Aten
28 July 2010
Slope Variability Concerns

Aten 17 May 2010
updated 7 July 2010
for discussion

Variation D

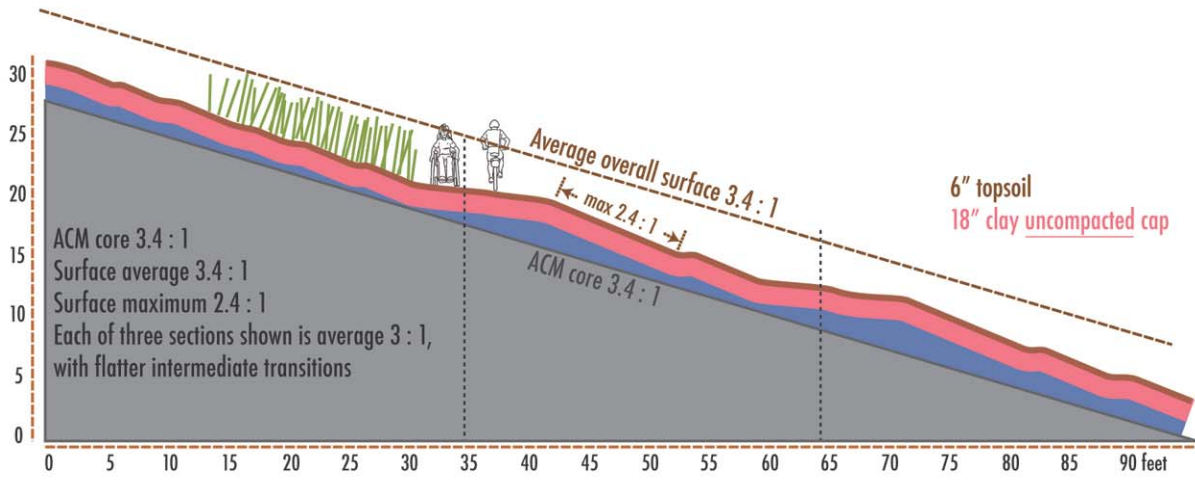
I am inclined toward variation D in the attached as a reasonable compromise between tight fill accommodation and the above considerations, for those (significant) portions of the plan with long steep slopes. (Of course, in variation D, I show the ACM core slope at 3.4:1, but if we don't have that much ACM, it can certainly be 3:1 with simply more clean cap on the lower slope :)).

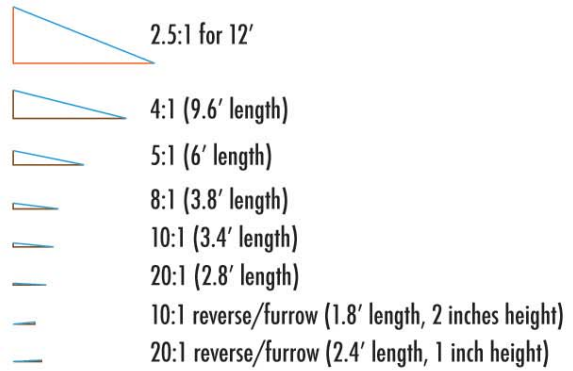
Understanding sections that "balance" 2.5:1 for 12 feet so that 3:1 average is maintained:

Basic geometry: if "s" is the more gradual slope of the form s:1, like 4:1, then the vertical element of the more gradual section is $v = 2.4 / (s - 3)$. I.e., a 4:1 section can drop (moving downhill) $2.4 / (1)$ or 2.4 feet, with a horizontal length of $4 * 2.4$ or 9.6 feet.

For a reverse grade section (a furrow/swale) that balances the 2.5:1 section, $v = 2.4 / (s + 3)$. I.e., a 10:1 reverse slope can rise (moving downhill) $2.4 / 13$ or 0.18 feet, or 2 inches, with a horizontal length of $10 * 0.18$ or 1.8 feet.

Variation E

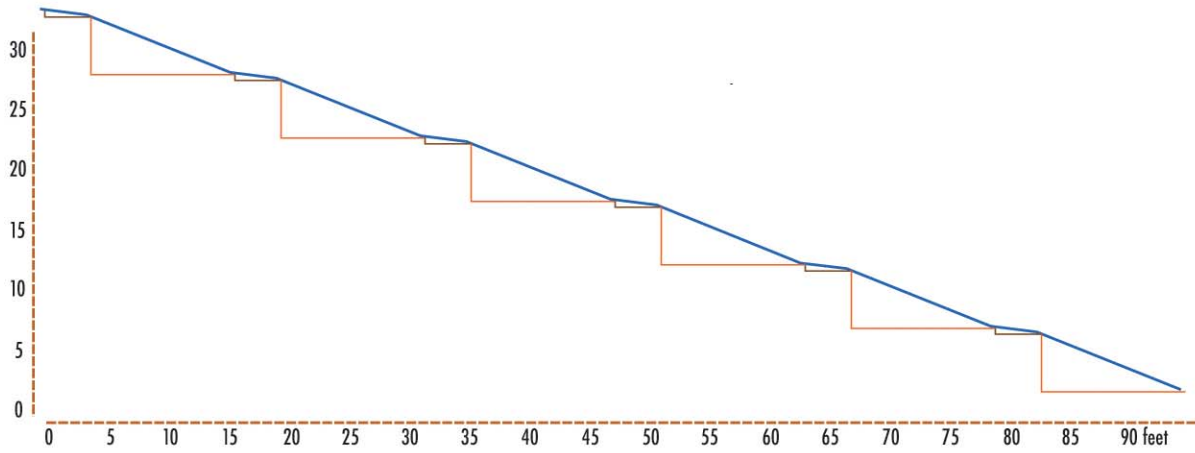
- (3) Reducing erosion by using microtopography to connect rainfall to root establishment. Again, another way of looking at (1) or (2). I agree with CDF's comment that variation E can support erosion control, but we're going for great, not minimum.

I believe that variation E will, in later trying to meet the above considerations, result in the majority of those slopes being 2.5:1 with brief slight breaks every 12' that are insufficient to support the kind of variability desired.

Details on the proposed "E", 3:1 surface average, 3:1 ACM, and allowing 2.5:1 for 12' horizontal to provide variability. Maximizing the use of the allowed 12' steeper portions - to "balance" that section, for example, you can do 9.6 feet at 4:1, or 3.4 feet at 10:1, or have a 2 inch deep furrow/swale that is 1.8' long.

Assembling a longer slope comprised of as quite a few, but not quite the maximum, 2.5:1 12-foot lengths, one scenario might look like this:

Variation E-max

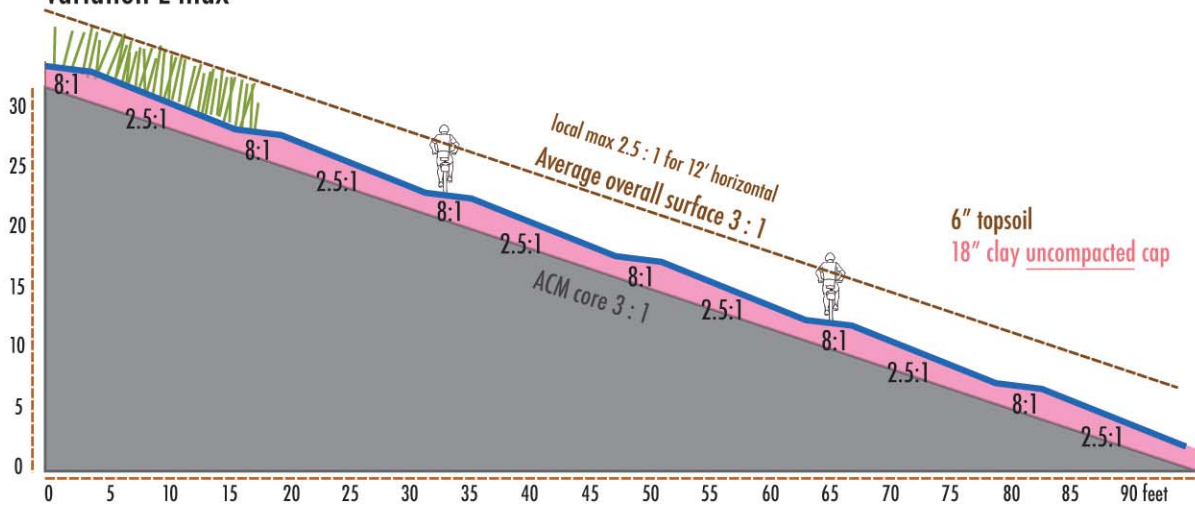
A longer slope comprised of maximum, 2.5:1 12-foot lengths (e.g. enabling most possible variation), separated by 8:1 (<4' wide) breaks would look like this. Note that 75% of this slope is at 2.5:1.
